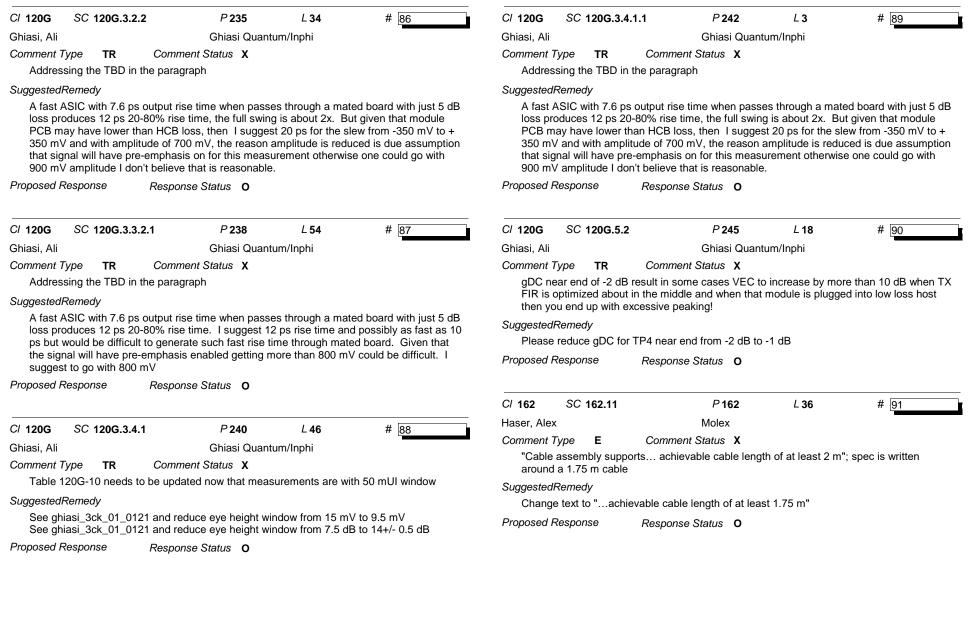
In table 120G-11 we refer to TP4 near end and TP4 far end, but table 120G-4 we refer to AUI-S and AUI-L short and long. It would be helpful to be consistent with the terminology.

I suggest replacing TP4 near end with TP4-S or short and TP4 far end with TP4-L or long to align with AUI-S/L.

The $\overline{A}UI$ short covers from TP4 near end up to 10.975 dB, and AUI long covers from >10.975 dB to 16 dB channels.
